Buzzing From the Engine at Low RPM

(Supersedes 06-059, dated November 10, 2006, to update the information by the black bar)

Template ID: 06-059A

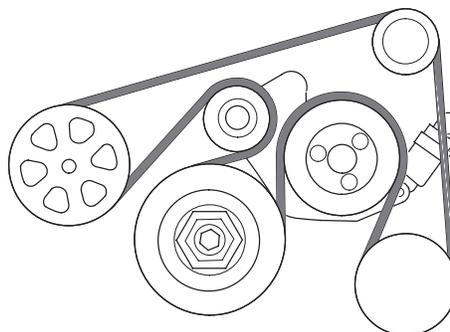
The drive belt layout allows drive belt tensioner noise to be heard in the passenger compartment.

Install a longer, re-routed drive belt.

1. Remove the original drive belt:
 - Refer to page 4-40 of the *2006–2007 Civic Service Manual*, or
 - Online, enter keywords **DRIVE BELT**, and select **Drive Belt Removal/Installation (R18A1 and R18A4 Engine)** from the list.
2. Install the new drive belt, and route it as shown.

NOTE: Use an appropriate tool for added leverage when setting the wrench on the auto-tensioner. The tensioner is hydraulic and should be moved slowly to relieve pressure on the belt. Applying excessive force to the tensioner can cause breakage.
